Council Study Session
City Hall Council Chambers
July 24, 2023

CITY COUNCIL MEETING
City Hall Council Chambers
July 24, 2023

d. Resolution Ratifying the Approval of the Preliminary and Final Plat for NORTH 100 BUSINESS PARK ADDITION and Authorizing Final Plat Recording

SHEET NUMBER
C300

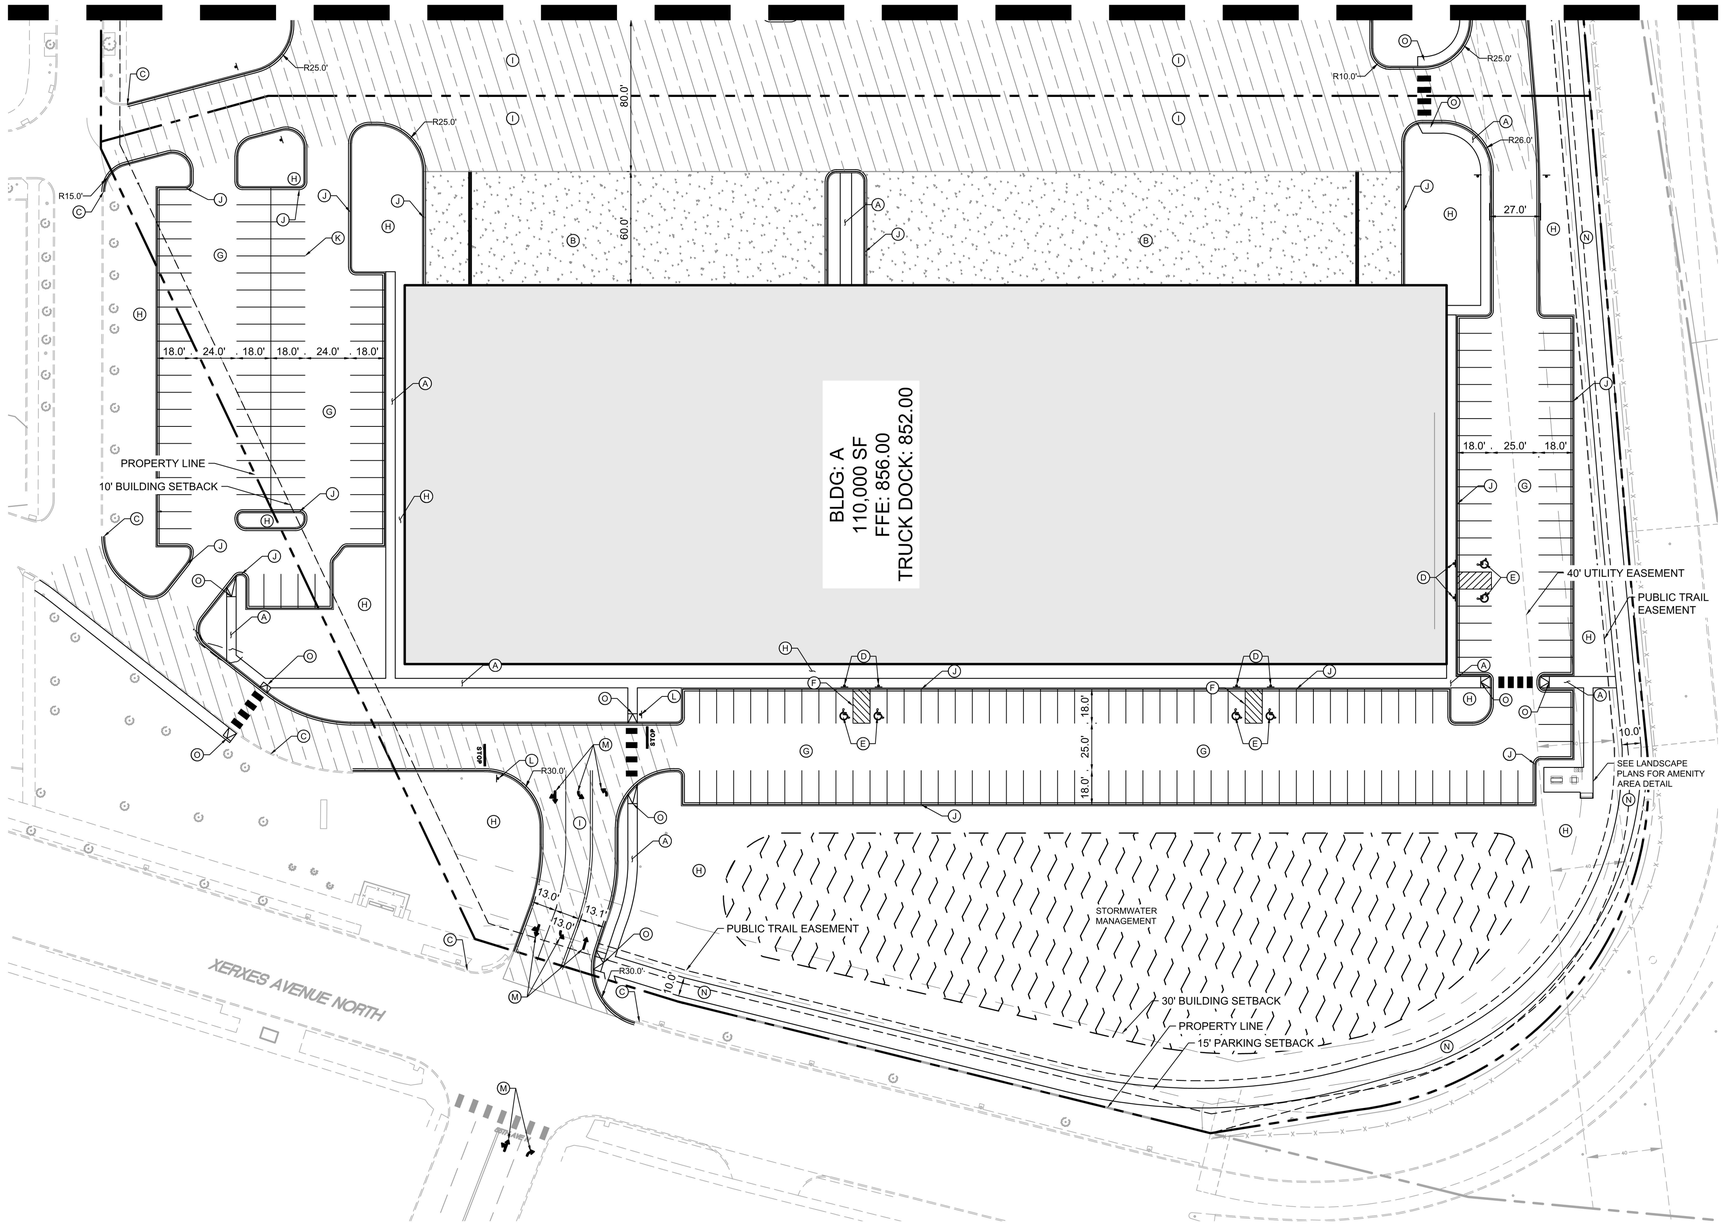
City staff reviewed the submitted overall site plan (Sheet C300) with the assumption of 80-percent industrial and 20-percent non-warehouse use (i.e. "office" for the purposes of calculating minimum parking). Similar stipulations were placed on approval of Planning Commission Application No. 2021-006, which was approved for the redevelopment of a former bowling alley located at 6440 James Circle North for an approximately 64,000-square foot business-flex building adjacent to existing hotels, office, and restaurants, and also located in a proposed area of redevelopment under the 2040 Comprehensive Plan.

SHEET NUMBER
L100

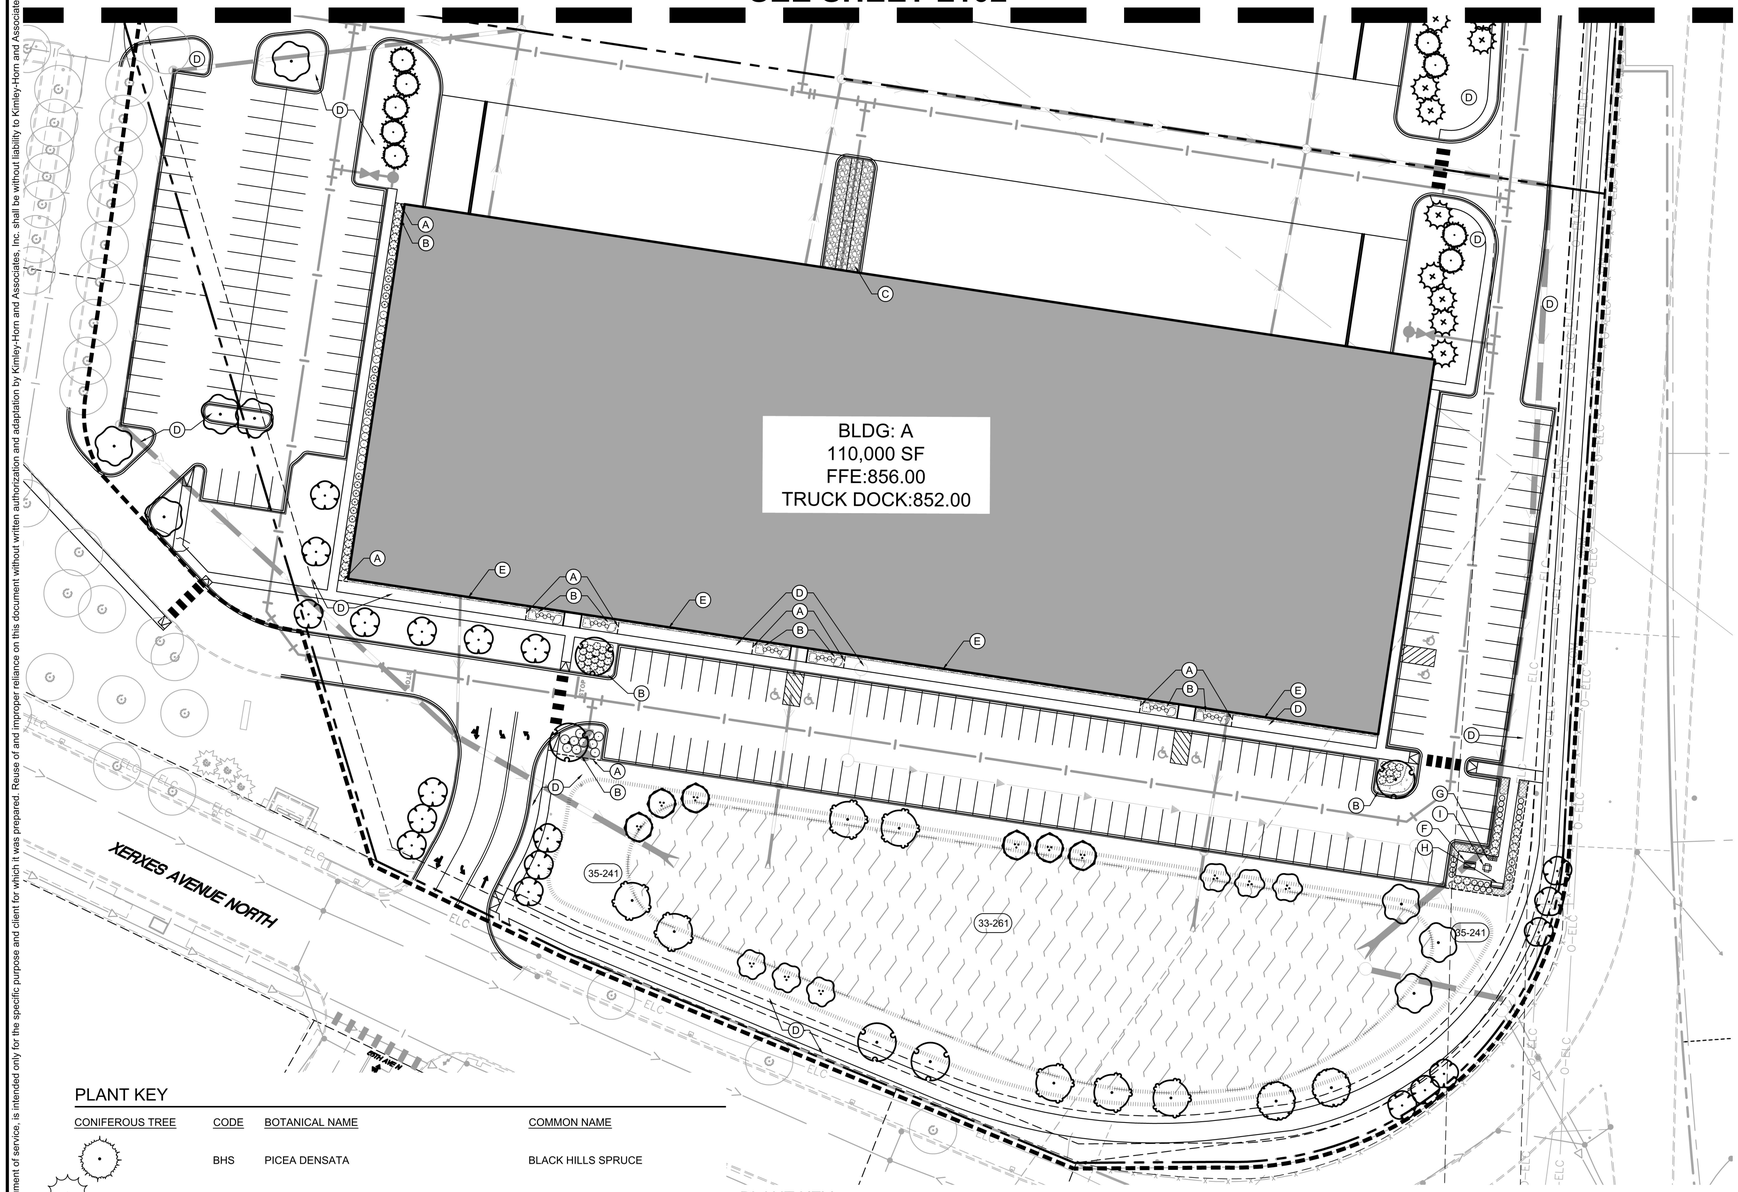
Subject Property's adjacency to a retail shopping center, City staff calculated the landscaping assuming the "Office/Industrial" use. It should be noted that the Overall Landscaping Plan (Sheet L100) clearly indicates an assumption of "Light Industrial," which has lesser requirements for landscaping. Assuming an approximately 15-acre site, the Subject Property would have to accrue 990 points. (2 acres * 90 + 8 acres * 70 + 5 acres * 50 = 990 points).

[ ] Denotes per REGISTERED LAND SURVEY NO. 936

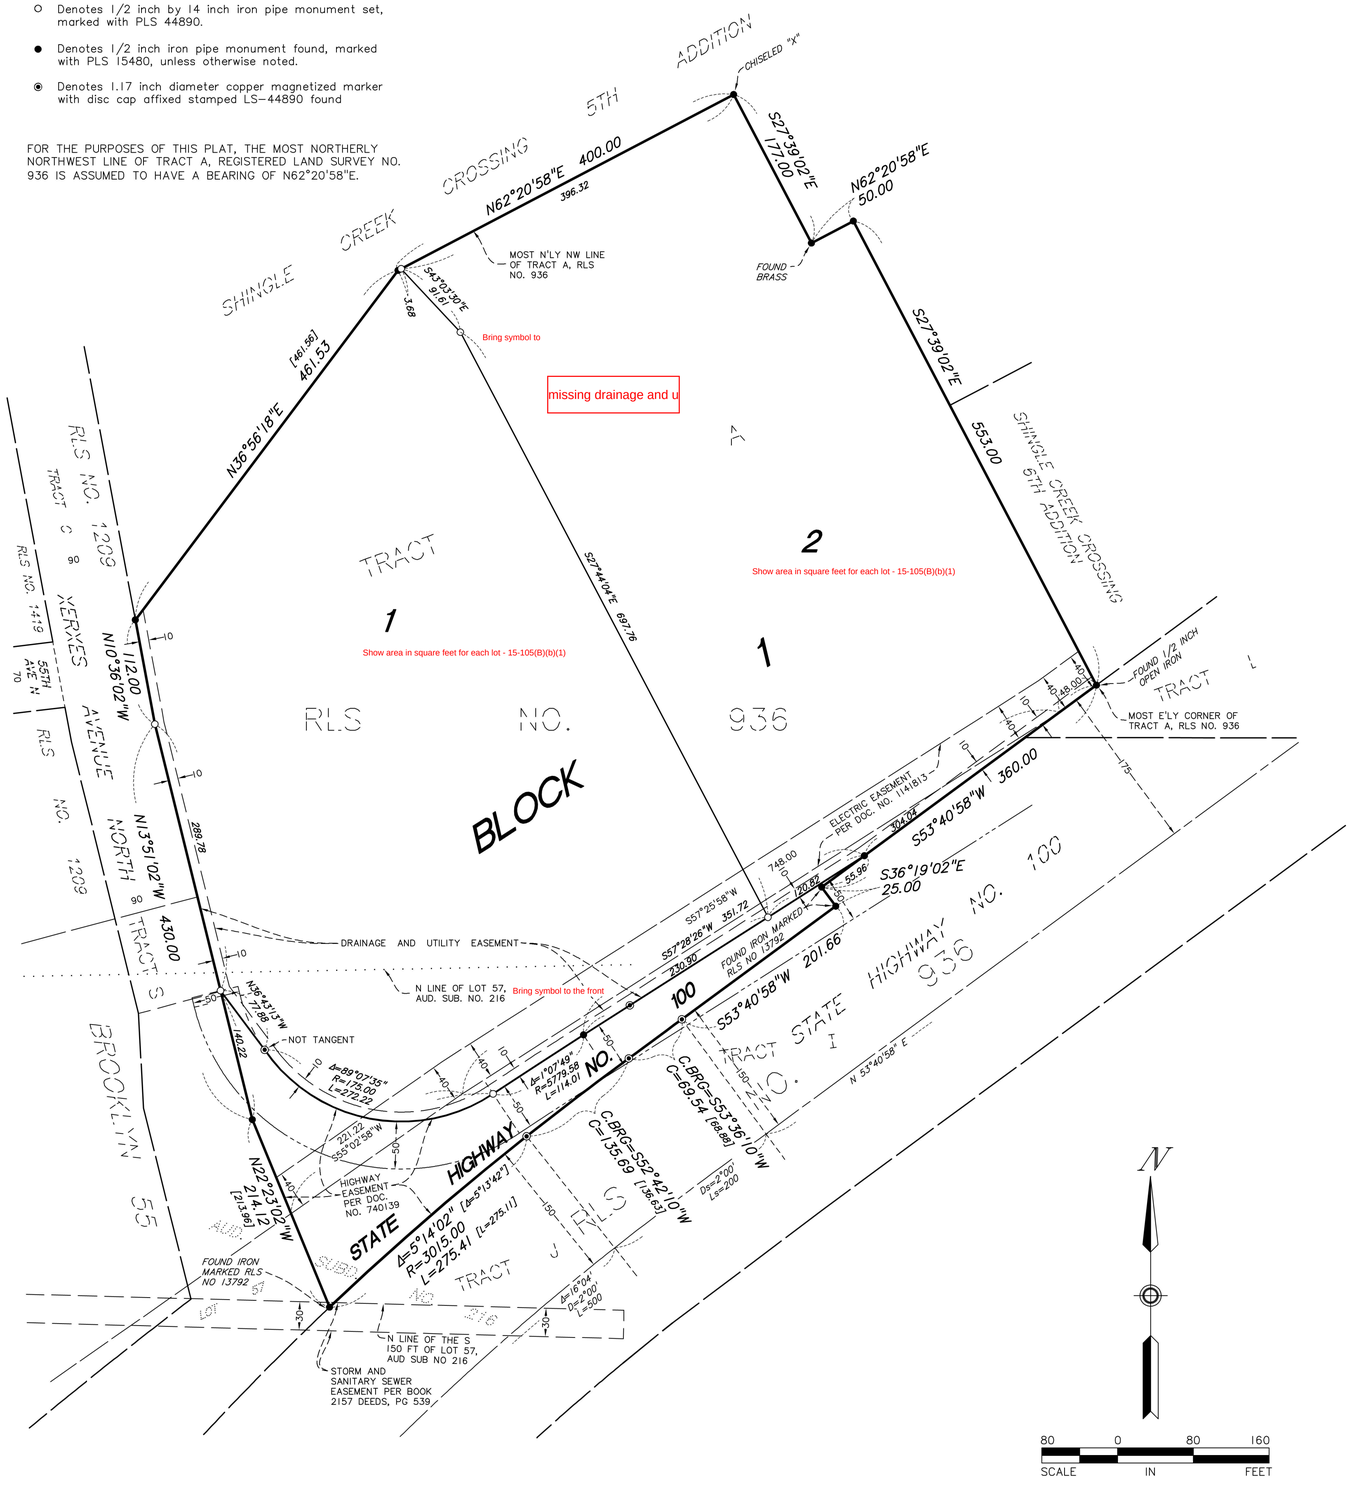
Show where underlying bearings differ - currently only showing distances

Image 10. Submitted Overall Photometric Plan with Proposed Lighting.

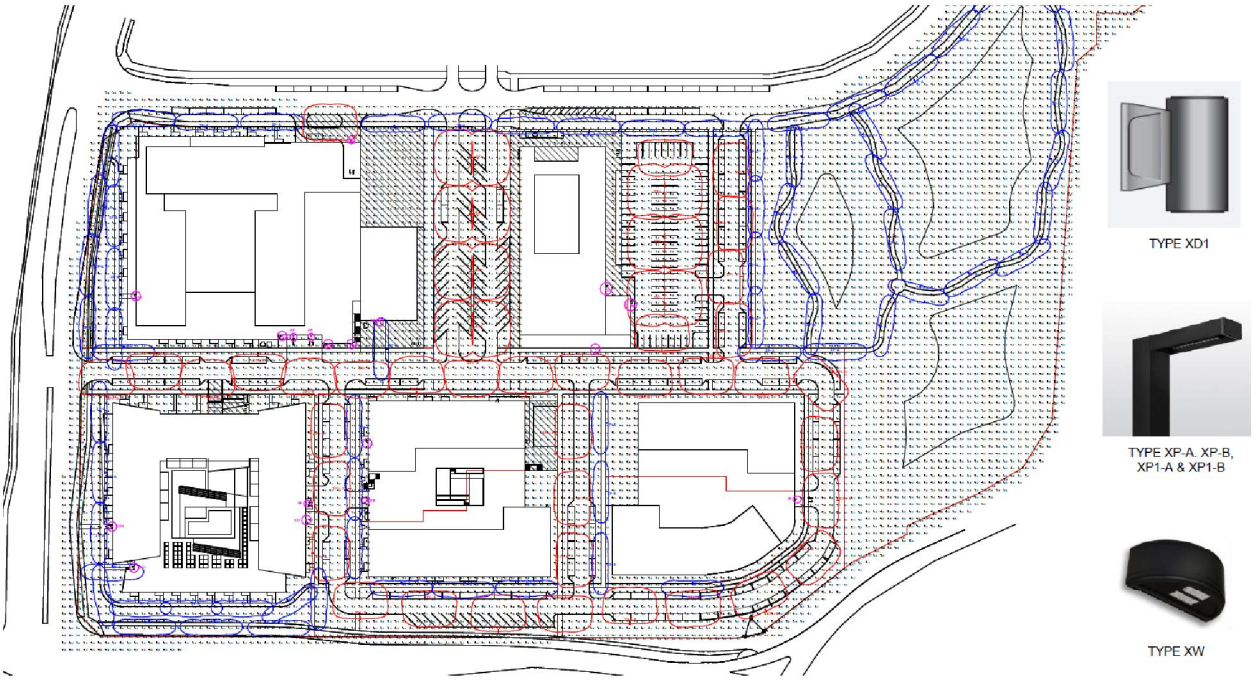
1. Revise overall PUD photometric plan to clearly note property lines on the overall PUD plans, and indicated on Sheet E015 (*Electrical Site Photometrics*). Minimum, maximum, and average foot-candles are presented in a table format and indicate maximum foot-candles at the property lines of between 0.01 to 2.8 foot-candles, which may require adjustment.

SHEET NUMBER
C300

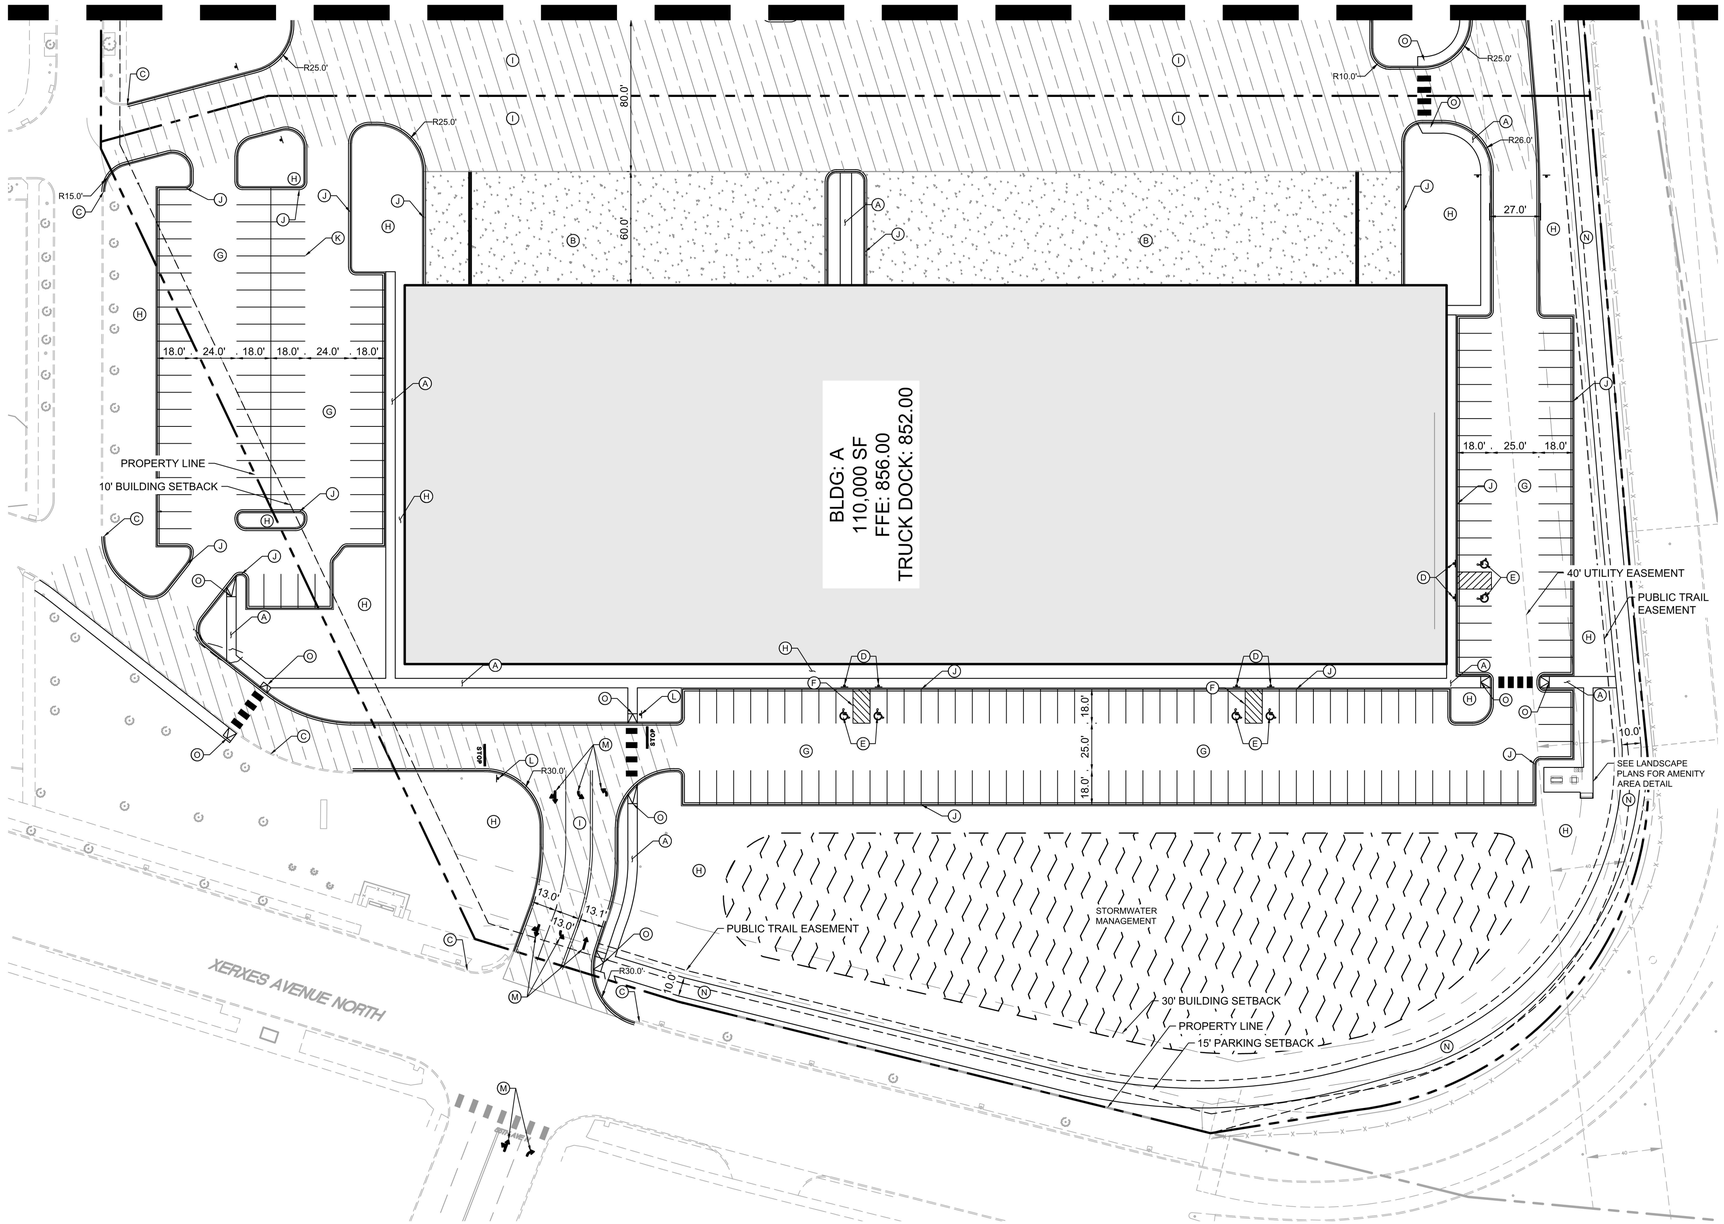
City staff reviewed the submitted overall site plan (Sheet C300) with the assumption of 80-percent industrial and 20-percent non-warehouse use (i.e. "office" for the purposes of calculating minimum parking). Similar stipulations were placed on approval of Planning Commission Application No. 2021-006, which was approved for the redevelopment of a former bowling alley located at 6440 James Circle North for an approximately 64,000-square foot business-flex building adjacent to existing hotels, office, and restaurants, and also located in a proposed area of redevelopment under the 2040 Comprehensive Plan.
